Development Facilitation Team (DFT) – Review Comments

Project No: PR-2023-009209 Date: 02/14/2024 Agenda Item: #3 Zone Atlas Page: NR-BP

Request: Proposing A 93K GSF Expansion of an existing 90K GSF Manufacturing Warehouse at 6625 Bluewater Road NW. This will include improvements for additional Onsite Parking, Onsite Drainage Features, Landscape, Lighting, and Wet Utilities.

Application For: SI-2024-00158 – SITE PLAT DFT

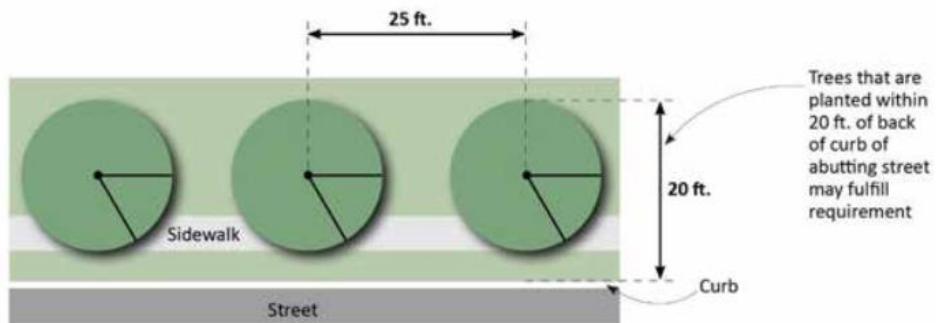
Please detail on the landscaping plan how the new street frontage trees are meeting the requirements in IDO 14-16-5-6(D)(1)(a), specifically the distance between species and the distance from the back of the curb on Bluewater.

1. Plans have added dimensions to show code compliance. Trees have been adjusted to fit within the 20'-0" landscape buffer and newly proposed 10'-0" UT easement. Proposing to meet code req. using existing trees on site that are outside of 20'-0" buffer. See alternate"

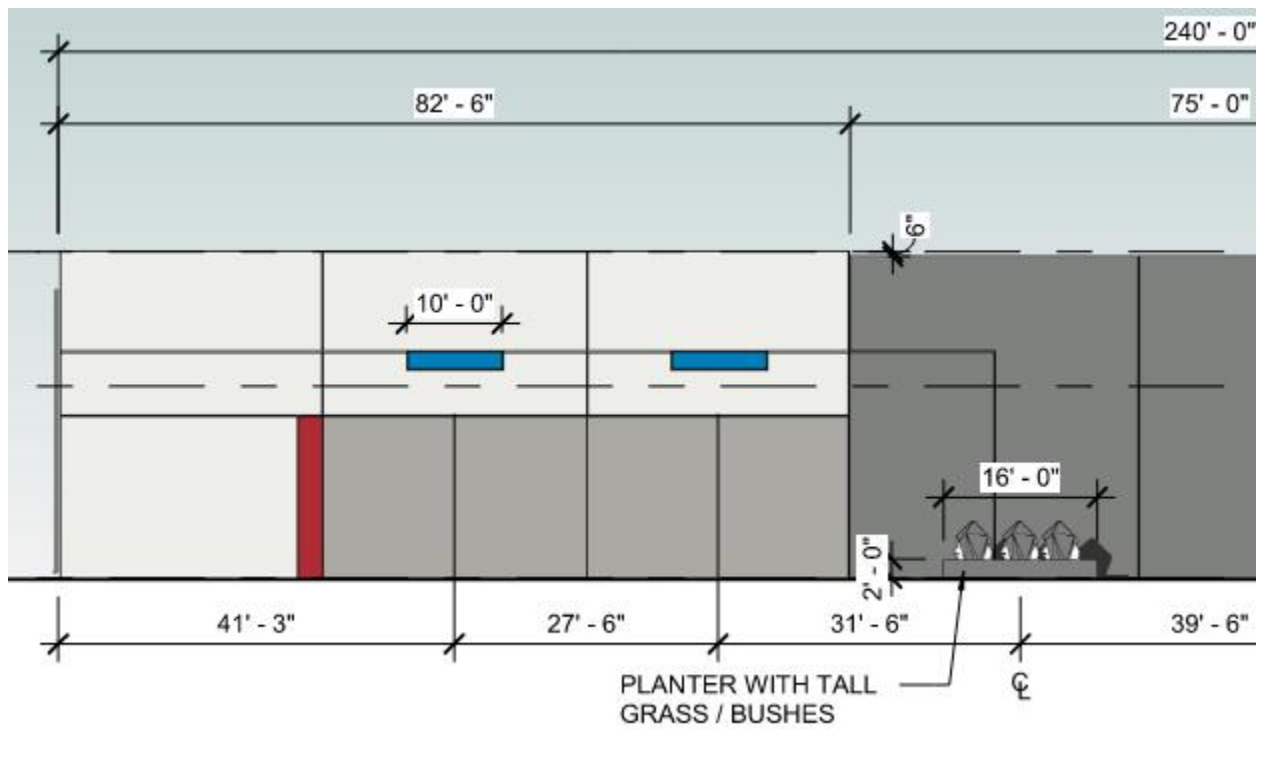
Please explain how the south facing façade is meeting these requirements. It does not appear that the street facing façade (south) is meeting minimum façade requirements.

Following our DFT site plan meeting today on 6625 Bluewater Road, I wanted to reach out regarding the south building façade and meeting IDO requirements. We had a meeting with Bonnie back in early November and presented revised elevations that include

- 1) Planter Boxes
- 2) Upper Level Windows

1. Per Coordination with Robert Webb & Bonnie Strange. The south facing facade meets the IDO requirements. See email coordination attached at the end of this PDF

These were deemed to have met the intention of the street facing façade requirements. Please see #2 from Bonnie in the attached email!
